**CALIFORNIA COASTAL COMMISSION**

## **A-5-LGB-19-0015 (LAGUNA CANYON CREEK EROSION)**

**OCTOBER 17, 2019**

### **EXHIBITS**

CITY OF LAGUNA BEACH  
PUBLIC WORKS DEPARTMENT  
CAPITAL IMPROVEMENT PROJECT NO. XXXX  
ANIMAL SHELTER FLOOD PROTECTION PROJECT  
ARTICULATED CONCRETE BLOCK DETAILS

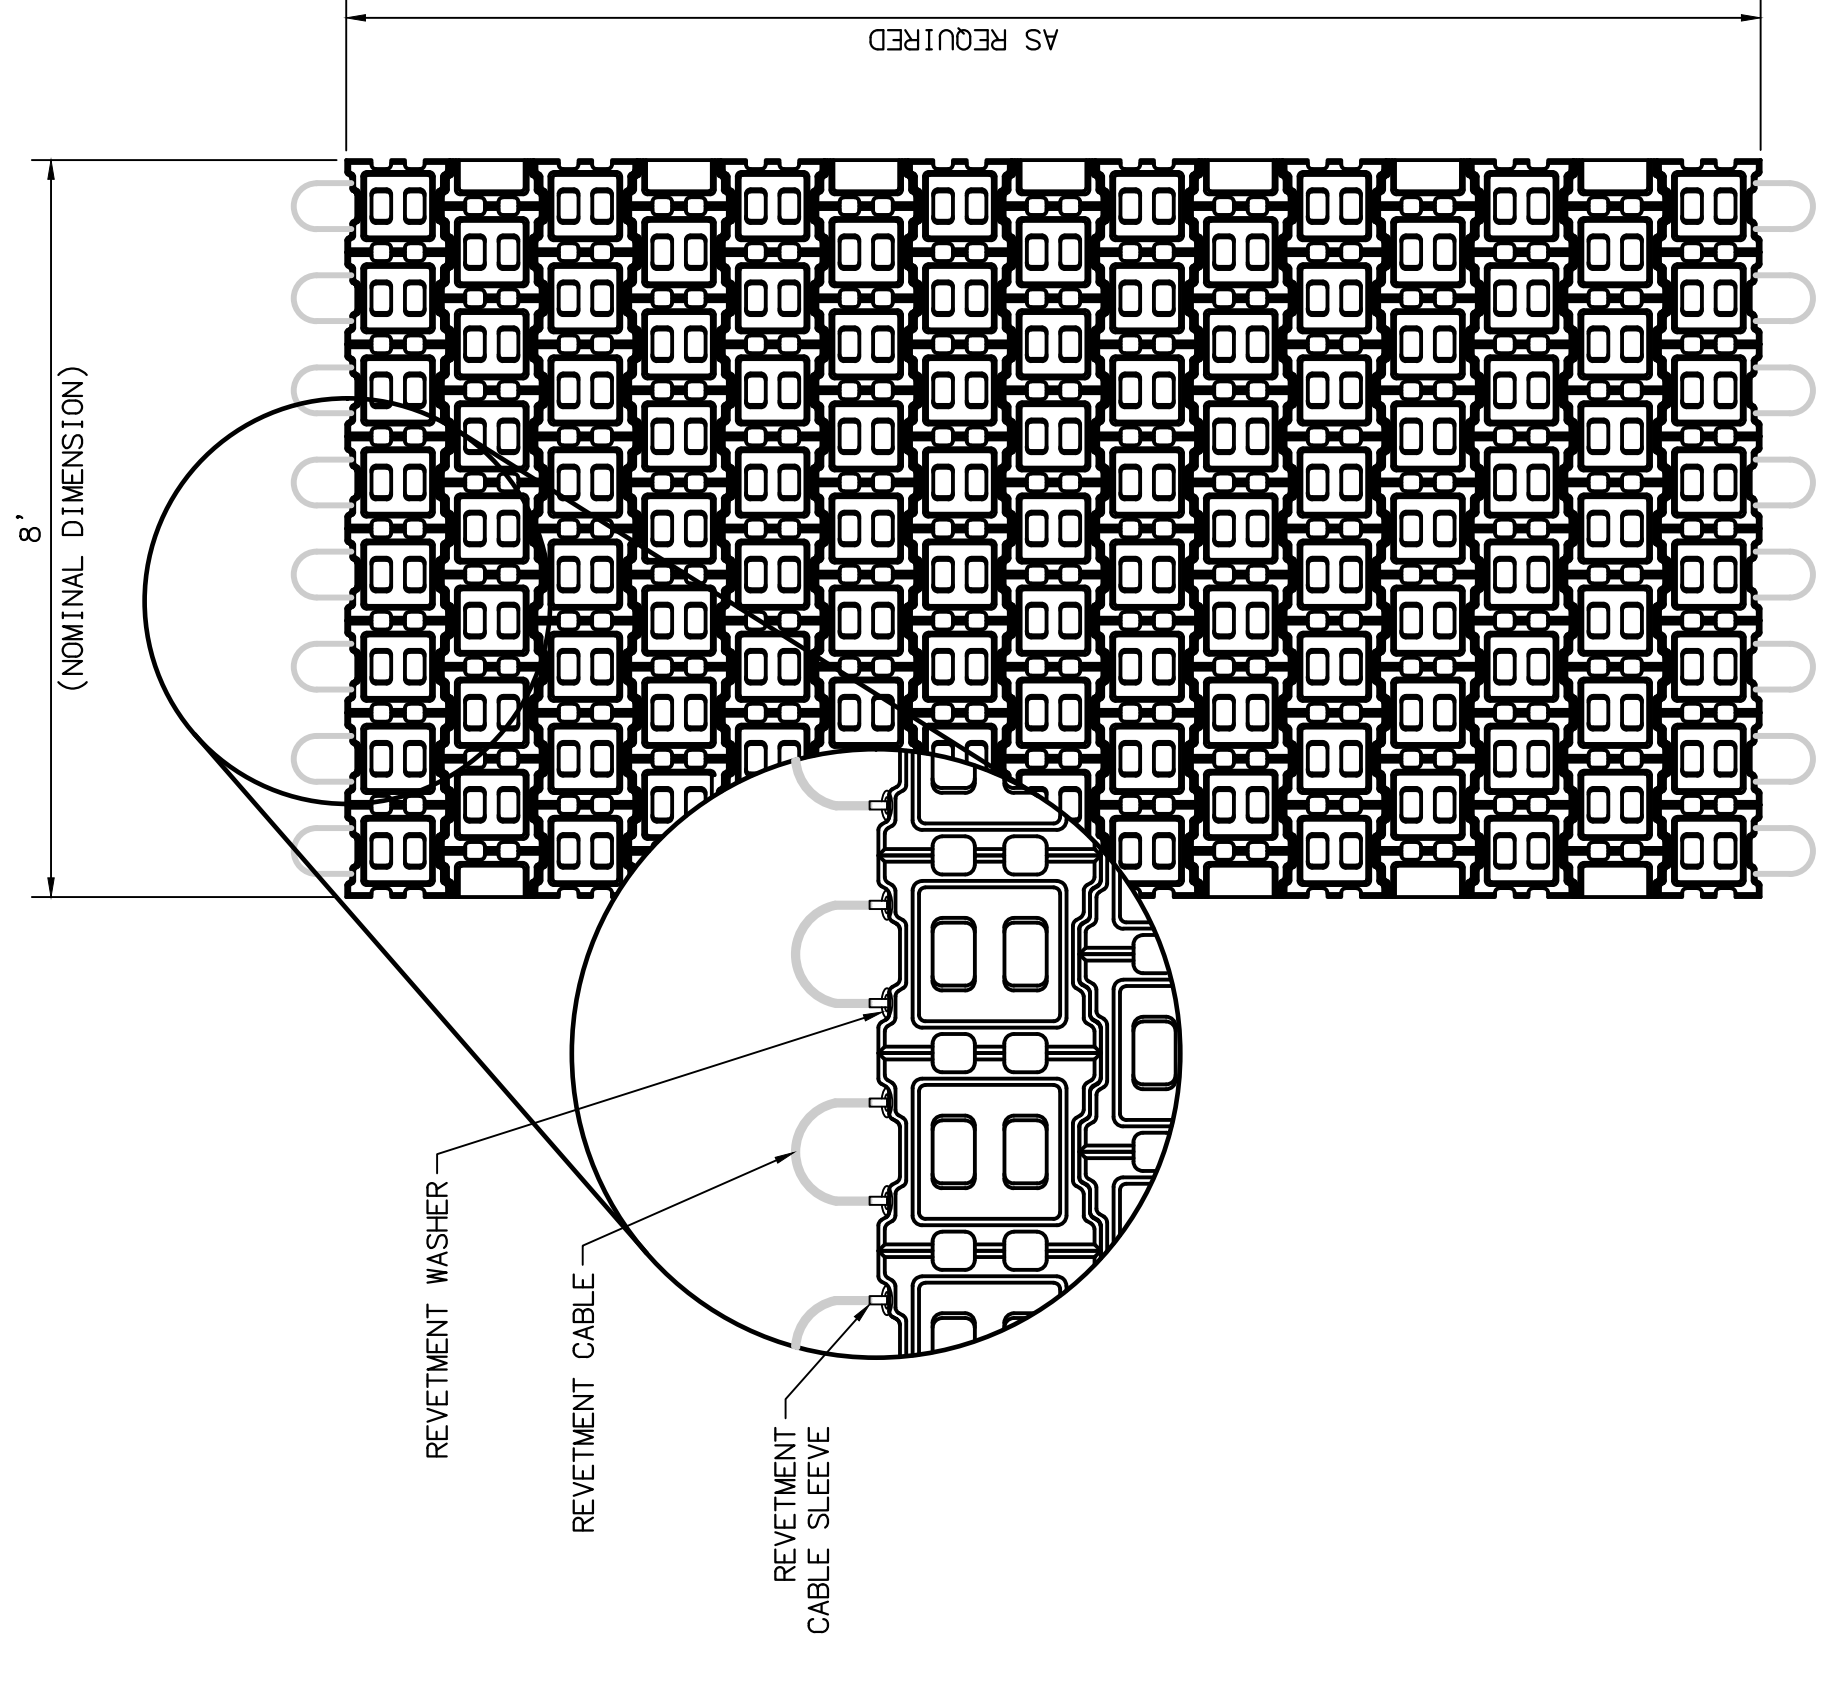
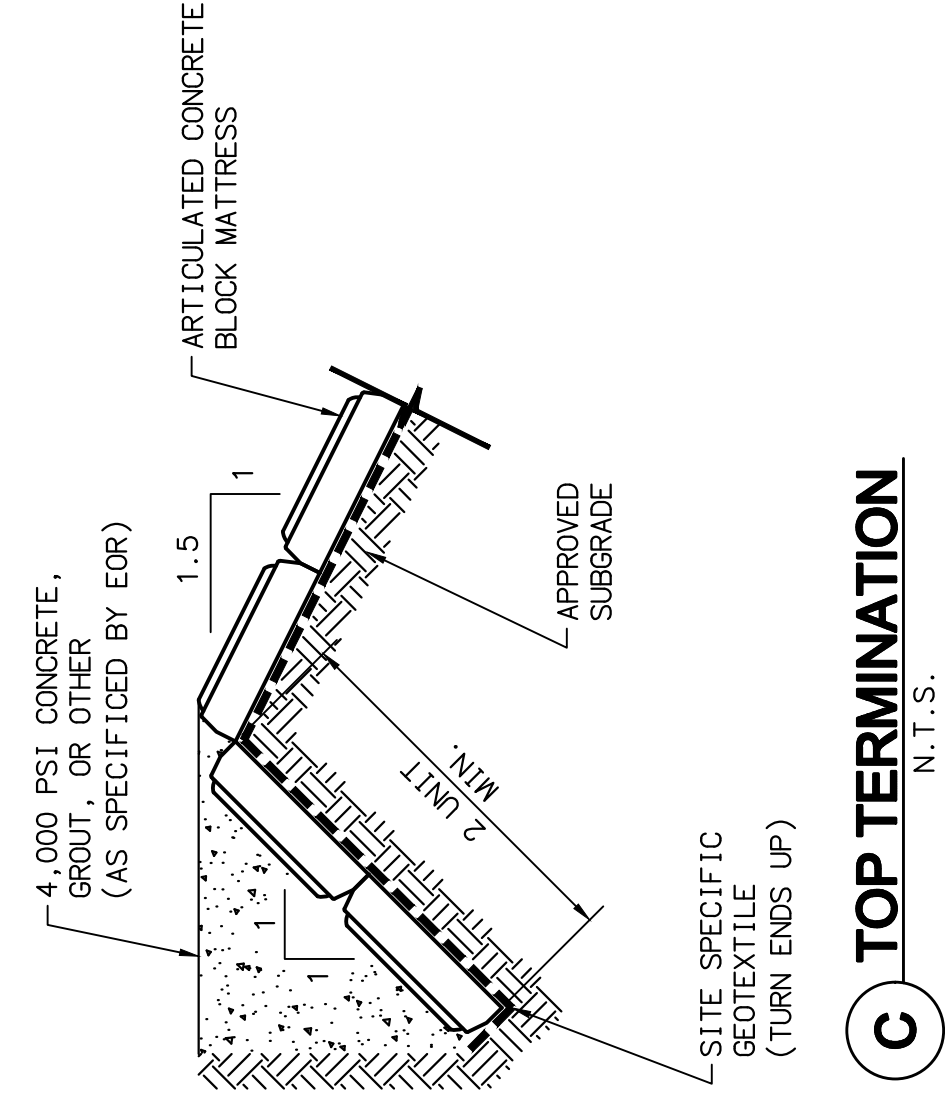
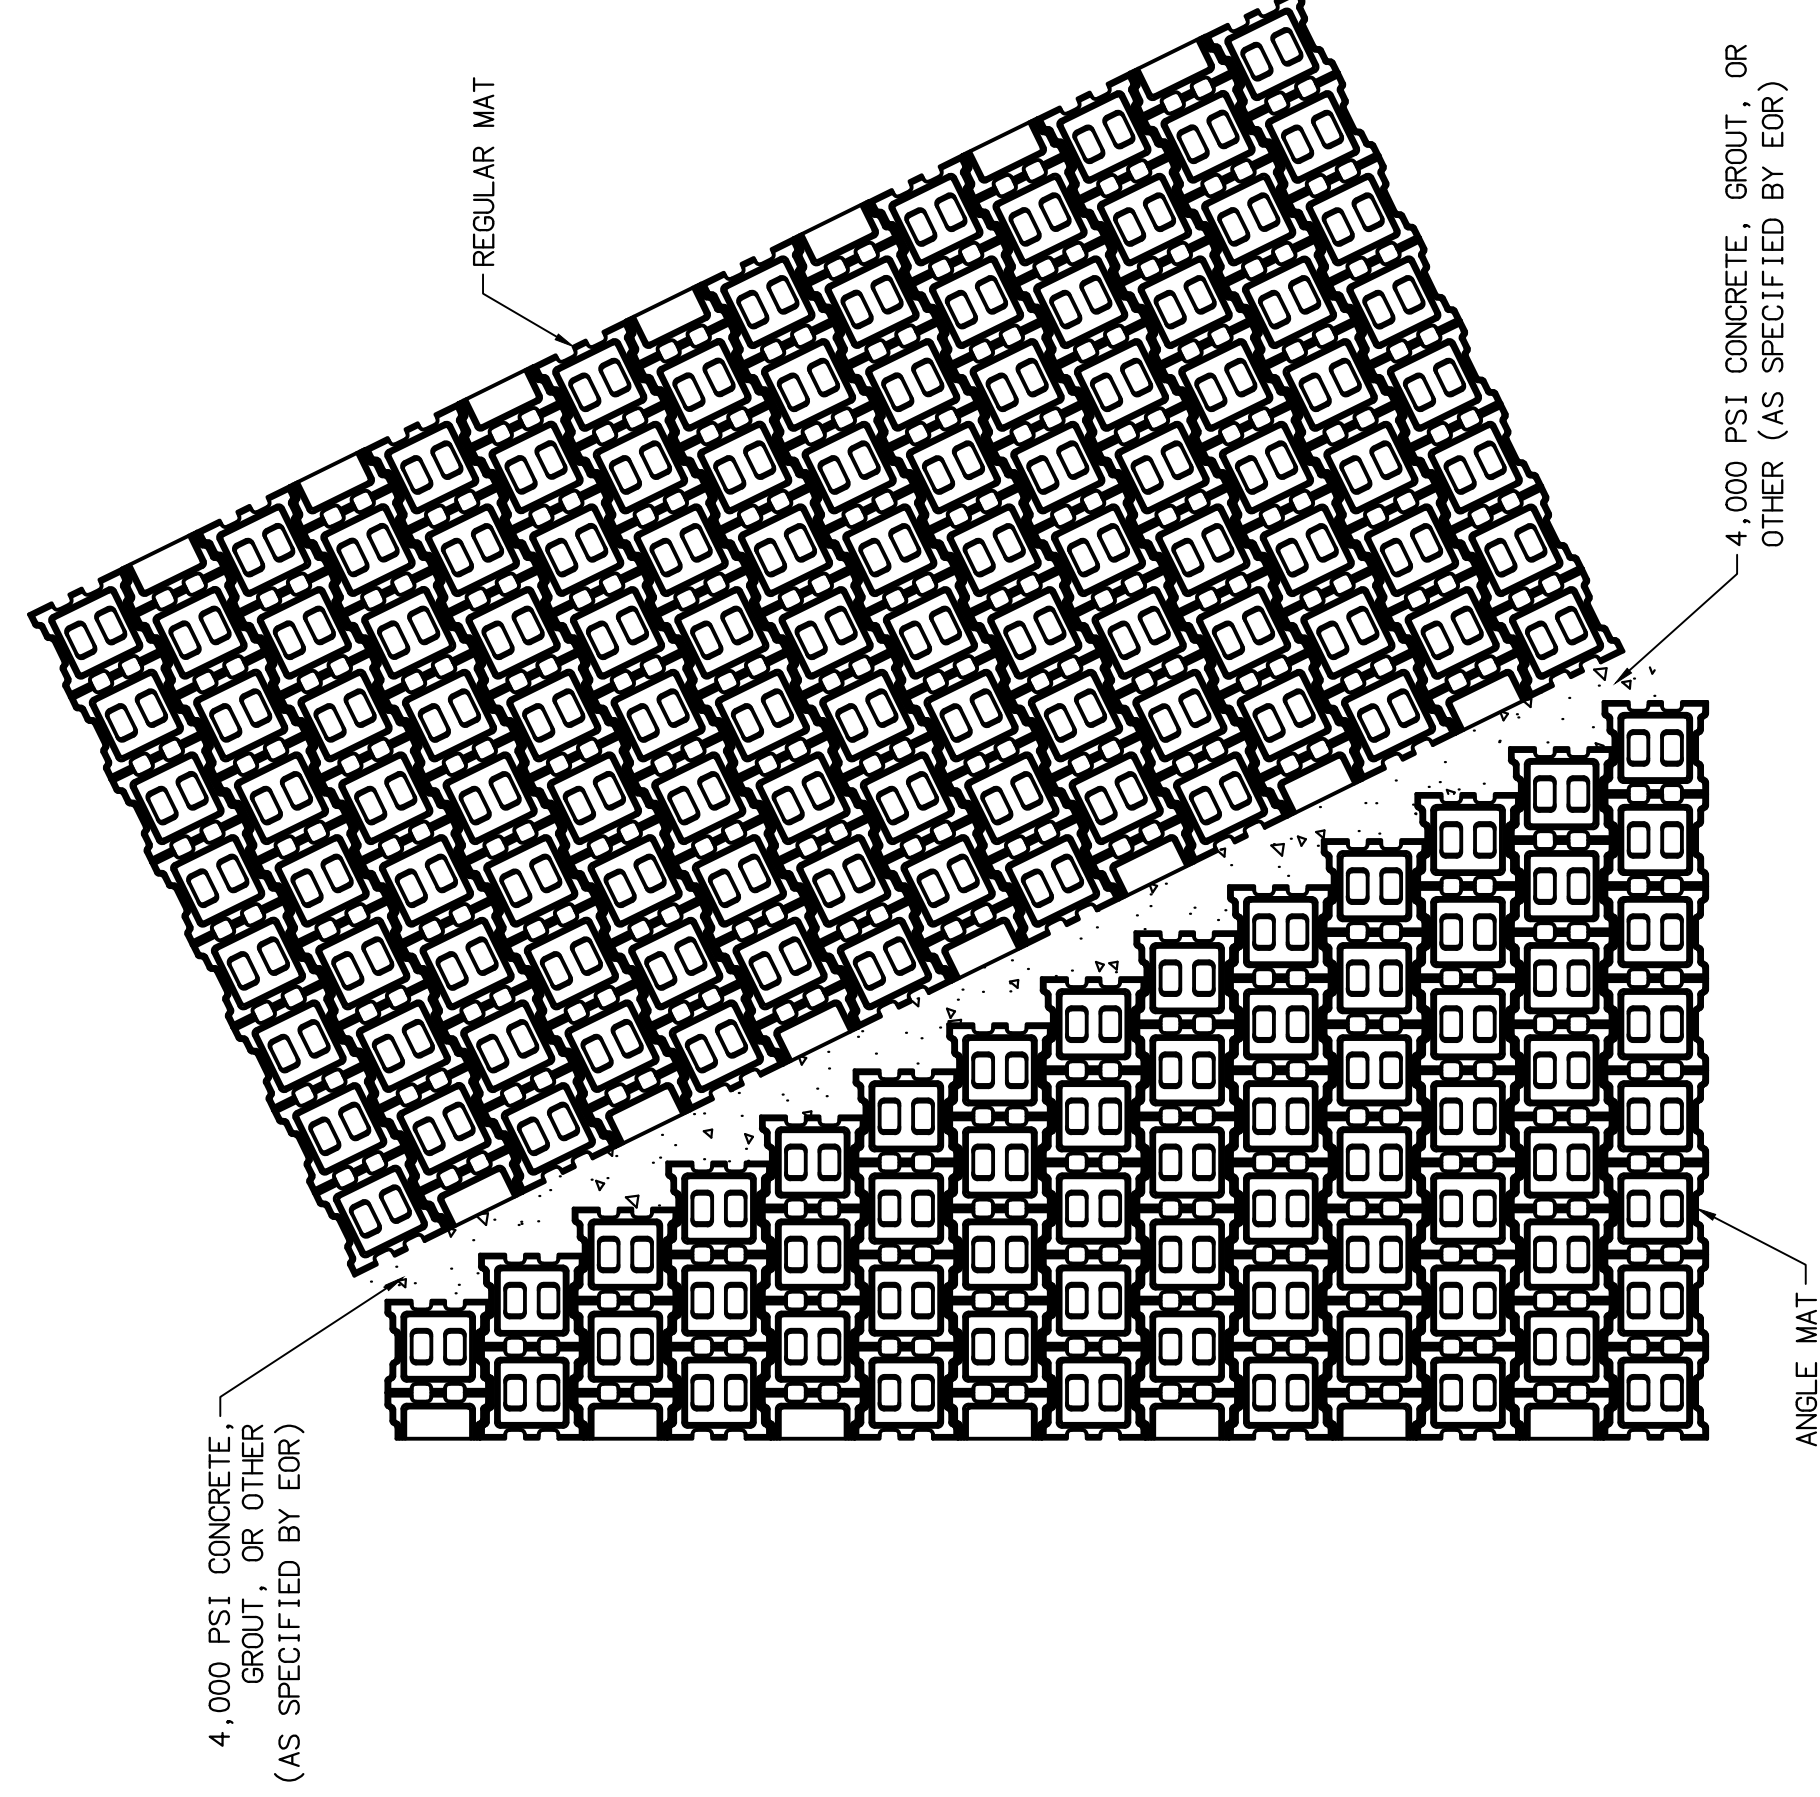
The proposed articulated concrete block (Armorflex) lining along both channel banks immediately north of the existing vehicular access bridge is required in order to prevent and control erosion of the creek banks. The channel floor remains a soft bottom, and the proposed Armorflex product
